METZGER PARK BASEBALL & SOFTBALL FIELDS

ADDENDUM #2

September 14, 2023

THRASHER PROJECT #101-T30-11111

PHASE No.	SHEET No.
CONTRACT No.	25
PROJECT No.

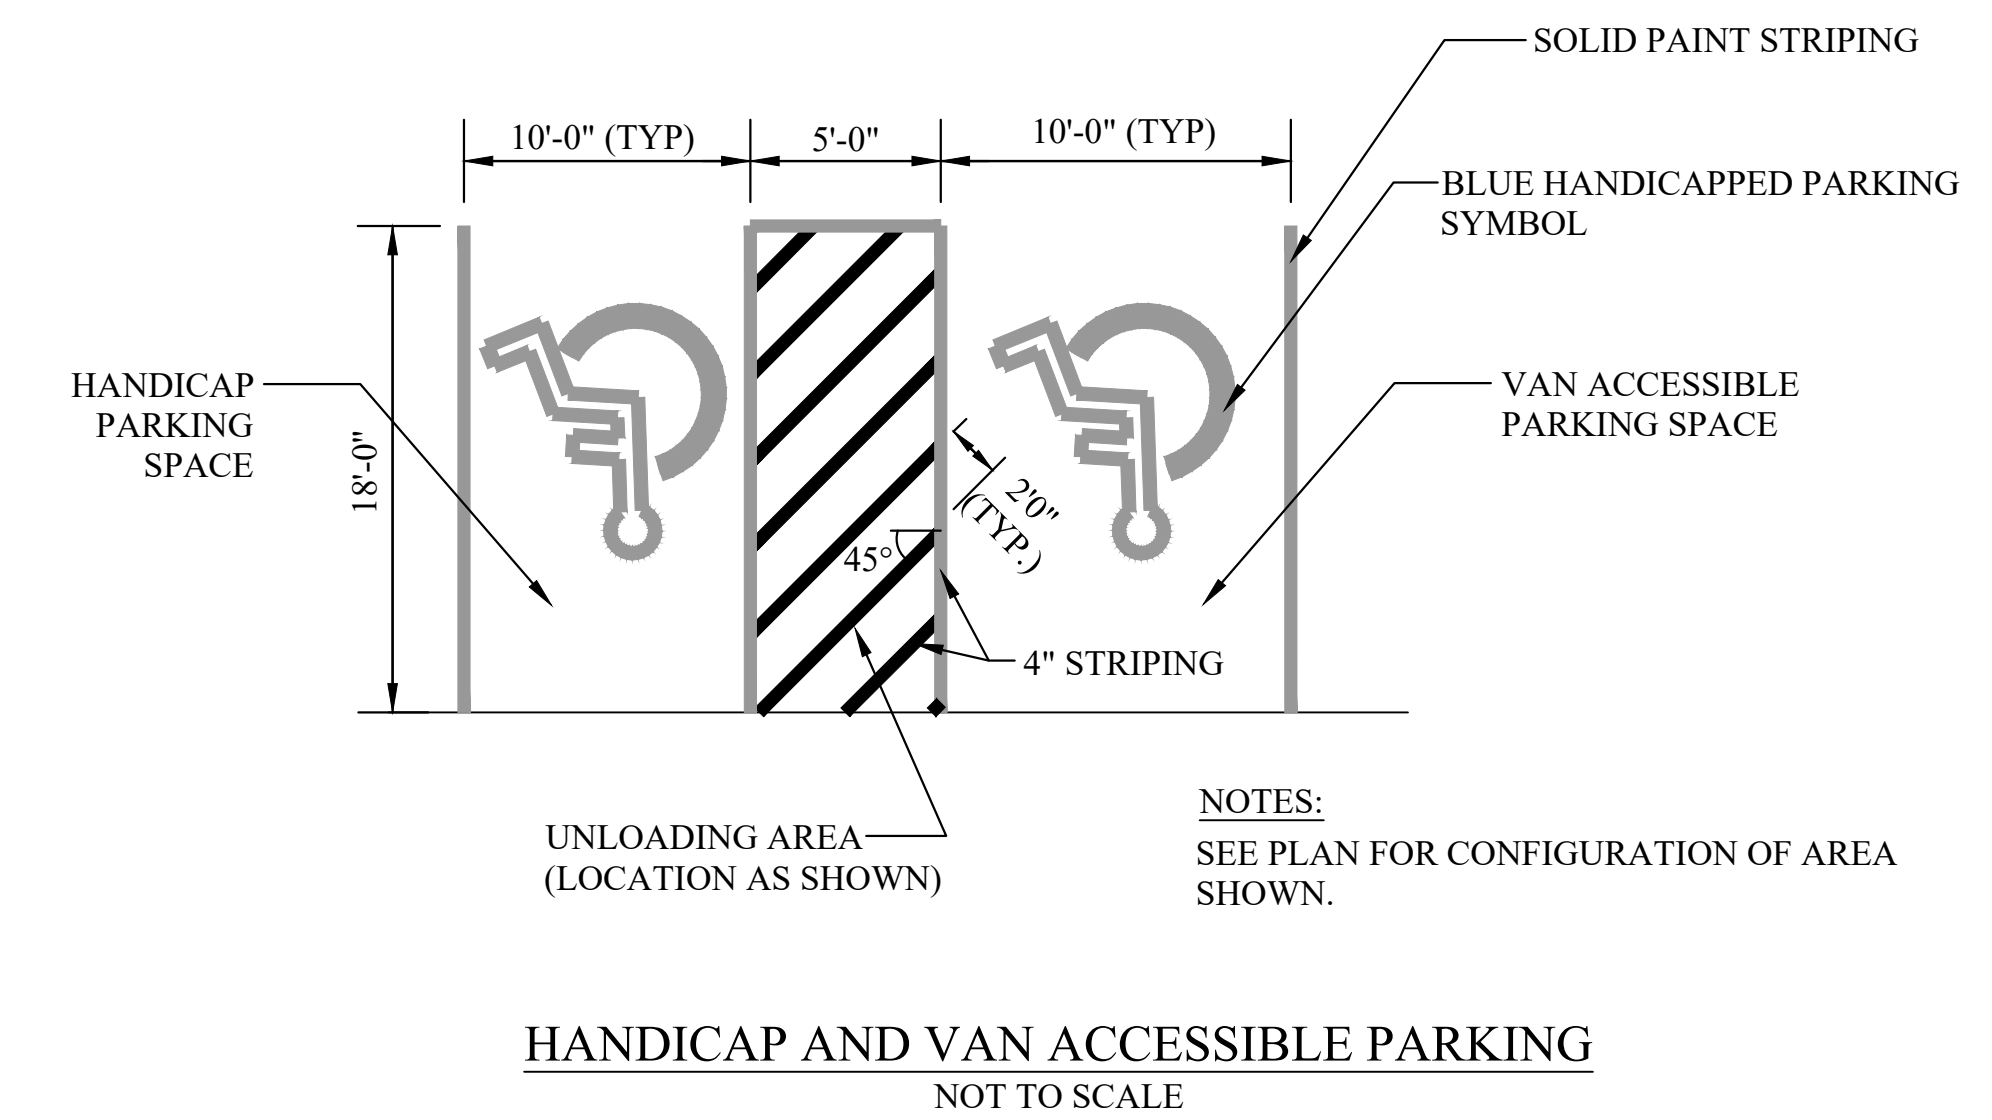
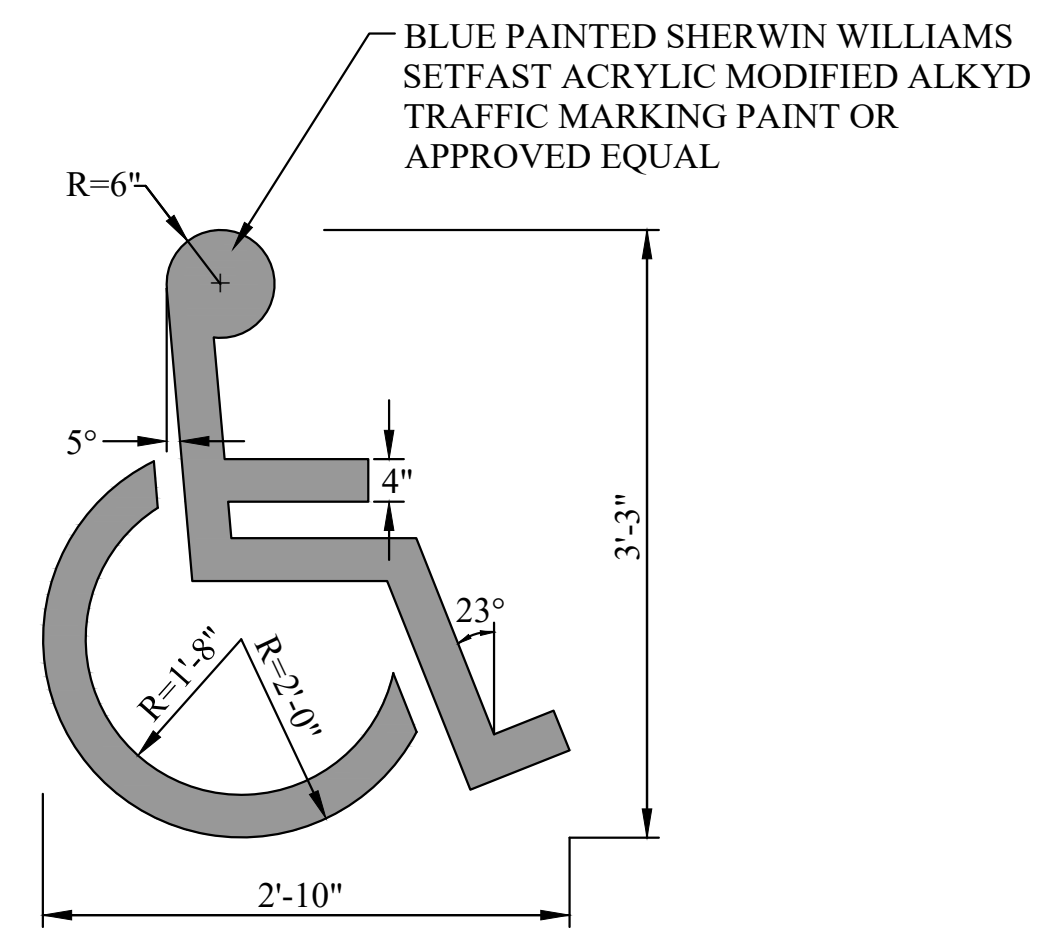
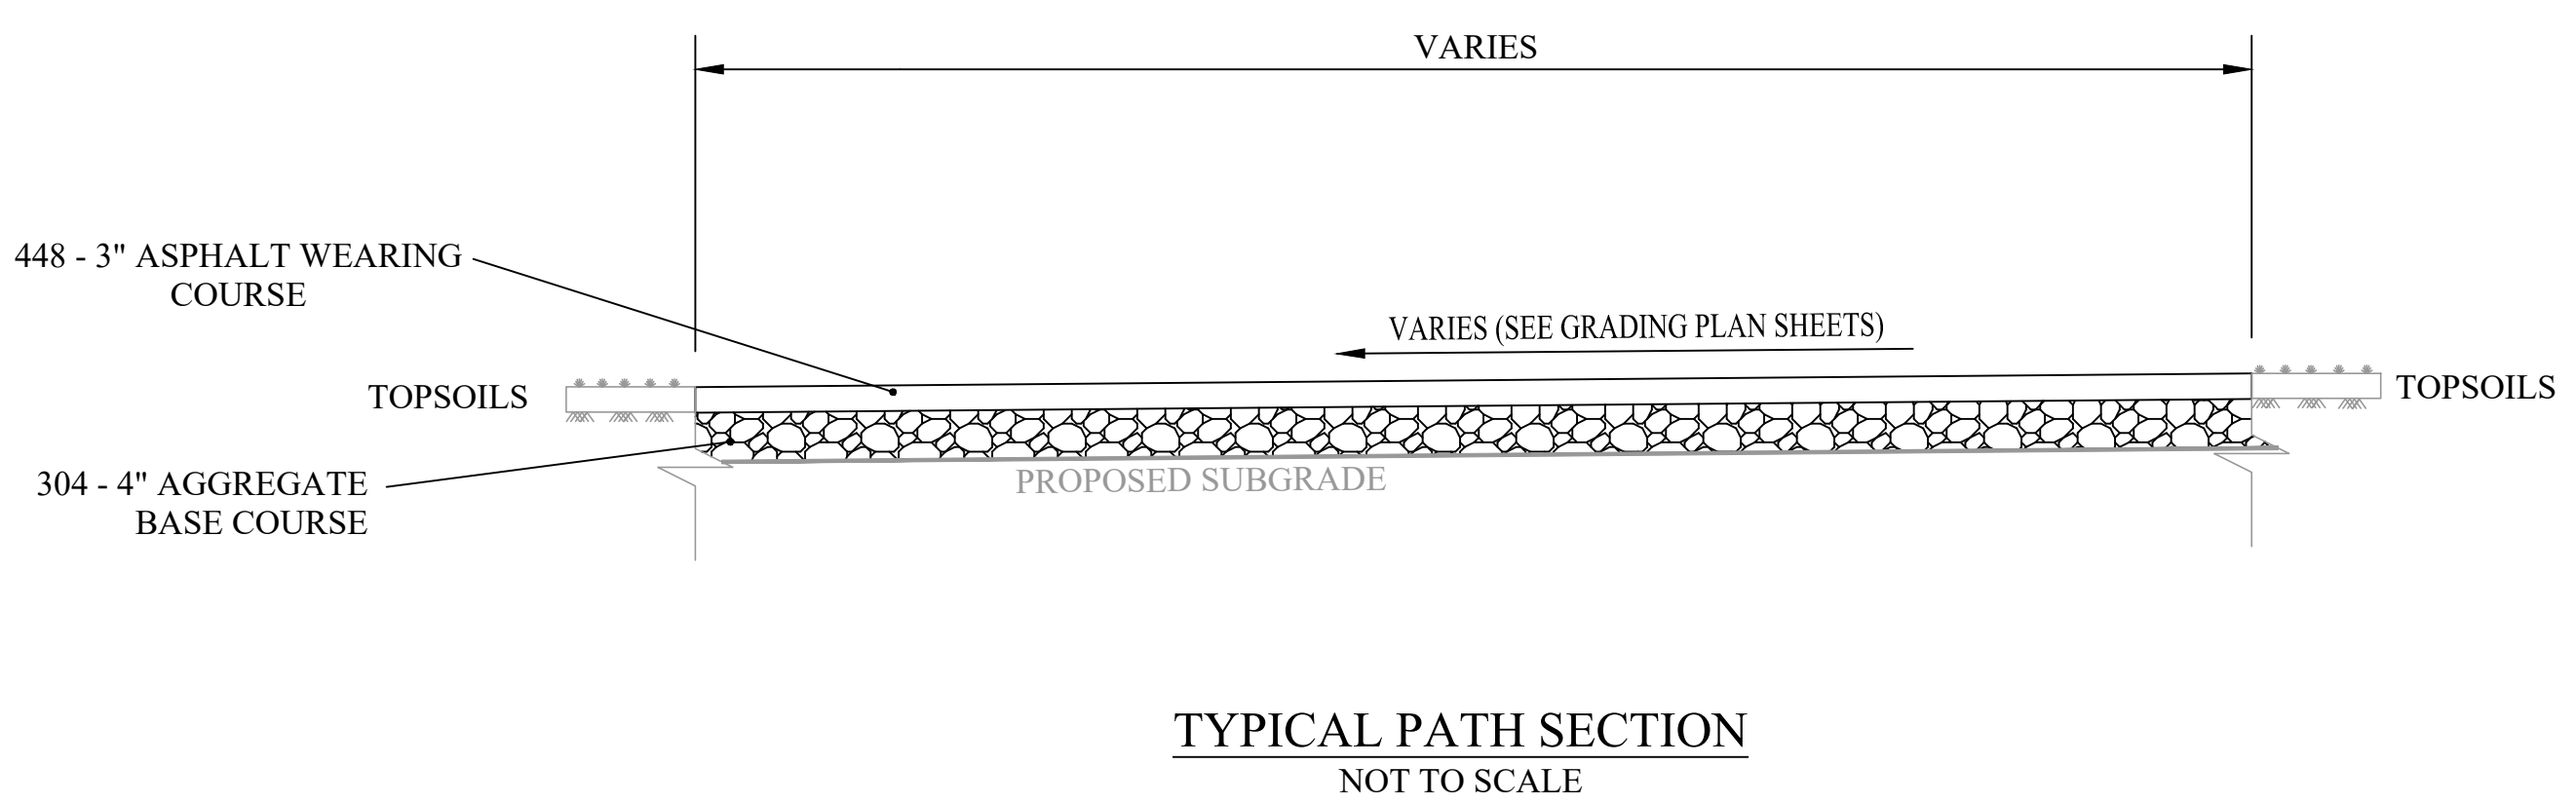
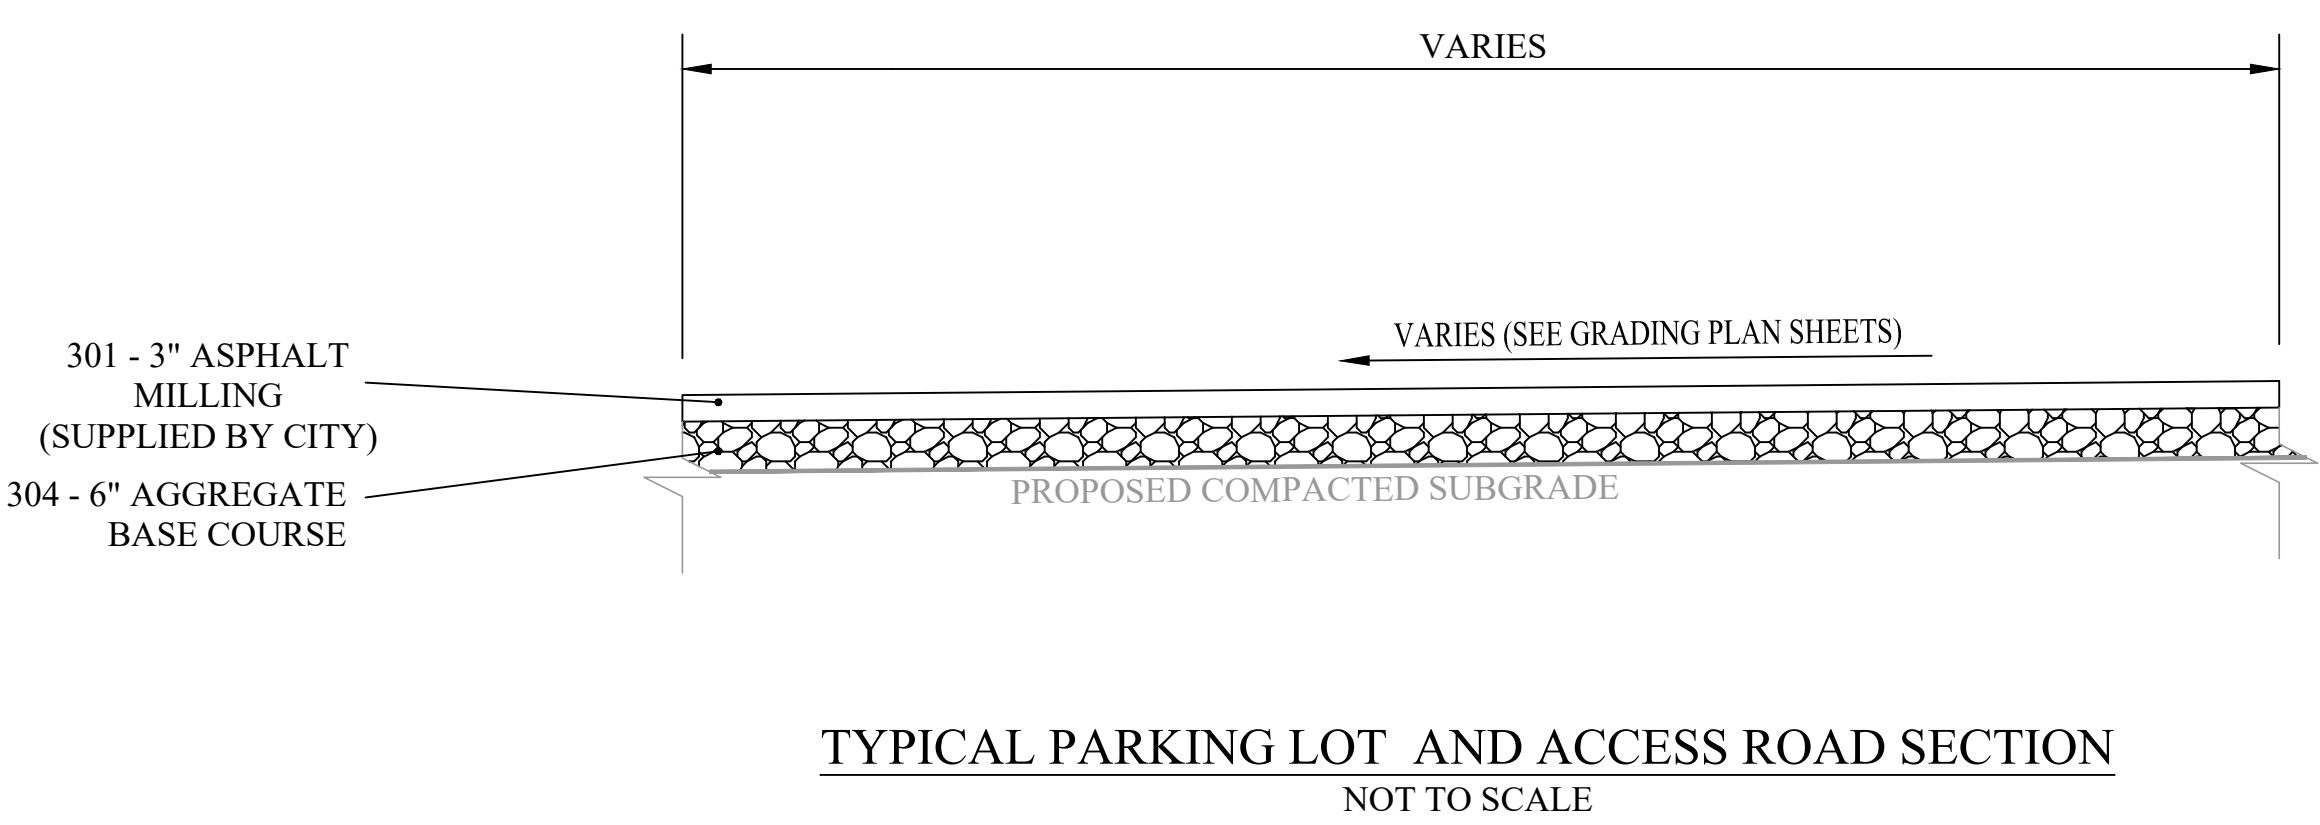
NO.	BY	DATE	DESCRIPTION
01	FMK	09/14/2023	ADDENDUM - 2 - WIDTH OF CONCRETE CURB HAS BEEN REVISED
